<b>AMENDMENT OF SOLICITATION/MODIFICATION OF CONTRACT</b>				1. CONTRACT ID CODE	PAGE 1 OF 3 PAGES
2. AMENDMENT/MODIFICATION NO. AMENDMENT NO. 0005		3. EFFECTIVE DATE 9-15-11	4. REQUISITION/PURCHASE REQ. NO.	5. PROJECT NO. (If applicable) 11-0116	
6. ISSUED BY CODE		sdb	7. ADMINISTERED BY (If other than Item 6) CODE		See Item 6
Officer in Charge of Construction MCI-East 1005 Michael Road Camp Lejeune, NC 28547-2521					
8. NAME AND ADDRESS OF CONTRACTOR (No., street, county, State and ZIP Code)				(X)	9A. AMENDMENT OF SOLICITATION NO. N40085-11-R-0116
				X	9B. DATED (SEE ITEM 11) 9-8-11
					10A. MODIFICATION OF CONTRACT/ORDER NO.
					10B. DATED (SEE ITEM 11)
CODE		FACILITY CODE

N40085-11-R-0116, Project # 11-0116, Repair Vehicle Maintenance Shop A2

PROTECTOR POST

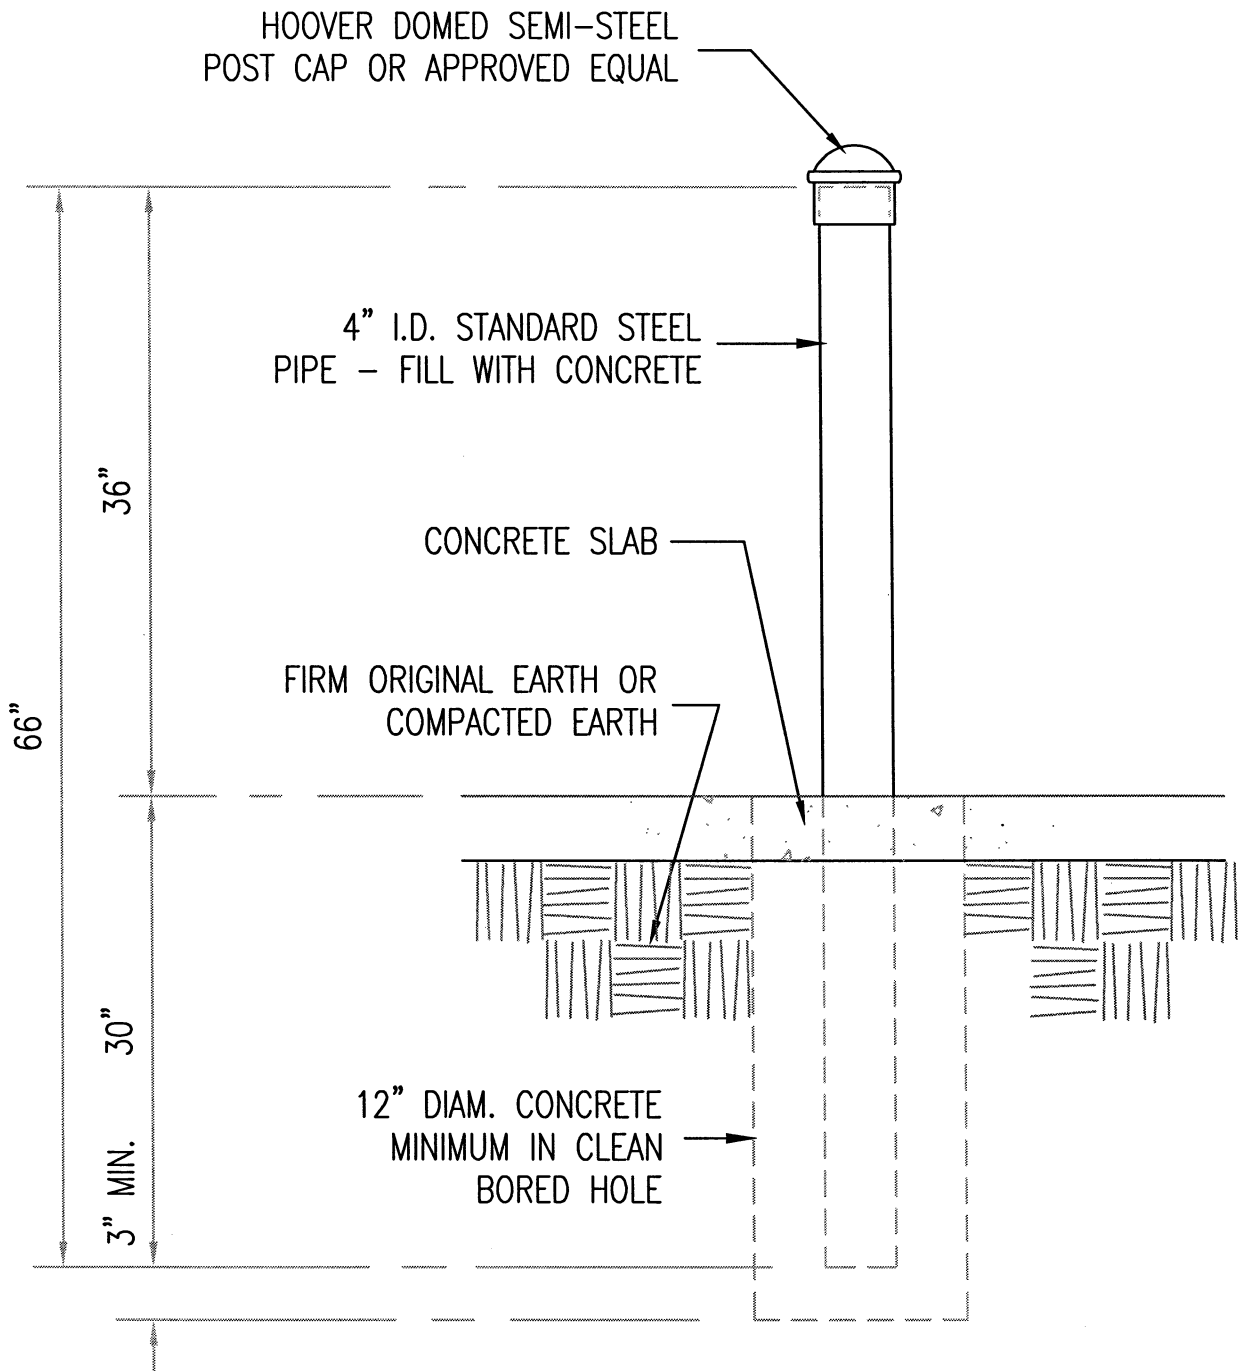
2. QUESTION: Will the contractor be required to install a concrete pad with bollard post, gas piping, 1st and 2nd stage regulators, etc, or bid as shown? The area on that side of the building is covered in concrete for tanks.

ANSWER: Provide a 5' W x 16' L x 4" thick concrete slab at termination location of the LP line, coordinate exact location with the contracting officer. Provide 6 galvanized protector posts as per attached Detail 2/SW3, one at each corner of the afore mentioned concrete slab and two along the middle of the 16'L side. Provide two coats of yellow enamel paint for the galvanized protector posts. Provide a first stage regulator, 250,000 BTU/HR capacity at the tank location.
